Access Compliance Report

Public Rights-of-Way

Intersection ID: 27002	Main Street: WALKER_RD	Cross Street: WEDDINGTON_RD	Location: NW
ADA ID: 3D149519B7F6	Ramp Type: Perp	Initial Pass/Fail: Fail	Overall Compliance: No
		Severity Score: 10

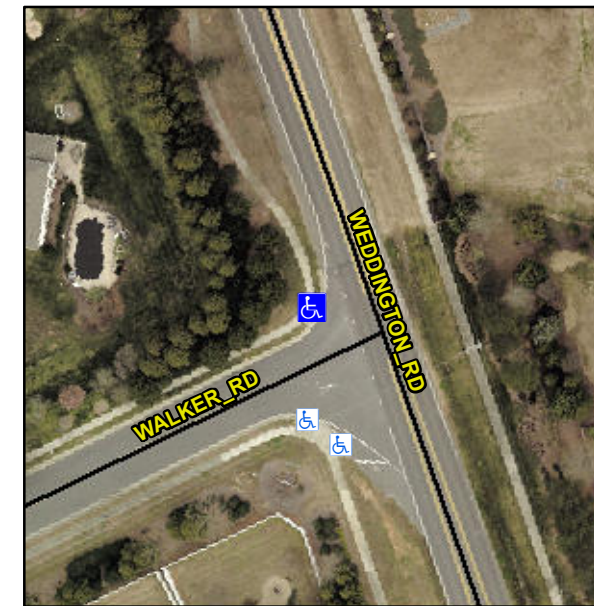
Not Found, R304.5.1, R304.5.3

Compliance	Description	Data	Compliance	Description	Data
N/A	Ramp Length (in)	48.0	Yes	Ramp Slope (%)	8.0
No	Ramp Width (in)	42.5	No	Ramp XSlope (%)	2.3
N/A	Flare Type LT	N/A	N/A	Flare Type RT	N/A
N/A	Flare Slope LT (%)	N/A	N/A	Flare Slope RT (%)	N/A
N/A	Flare Traversable LT?	N/A	N/A	Flare Traversable RT?	N/A
N/A	Landing Length (in)	N/A	N/A	DWS Provided?	N/A
N/A	Landing Width (in)	N/A	N/A	DWS Contrast?	N/A
N/A	Landing Slope (%)	N/A	N/A	DWS Length (in)	N/A
N/A	Landing X Slope (%)	N/A	N/A	DWS Full Width?	N/A
N/A	Landing Curb? (Y/N)	N/A	N/A	DWS Offset (in)	N/A
N/A	Shared Landing?	N/A			
N/A	Gutter Ponding?	N/A	N/A	Gutter Slope (%)	N/A
N/A	Gutter Lip Ht (in)	N/A	N/A	Gutter X Slope (%)	N/A
N/A	Painted X Walk1?	No	N/A	Painted X Walk2?	N/A
	X Walk 1 Direction	To S		X Walk 2 Direction	N/A
N/A	X Walk 1 Width (in)	N/A	N/A	X Walk 2 Width (in)	N/A
	X Walk 1 Slope (%)	2.4		X Walk 2 Slope (%)	N/A
	X Walk 1 X Slope (%)	3.0		X Walk 2 X Slope (%)	N/A

Remove & Replace Entire Ramp.
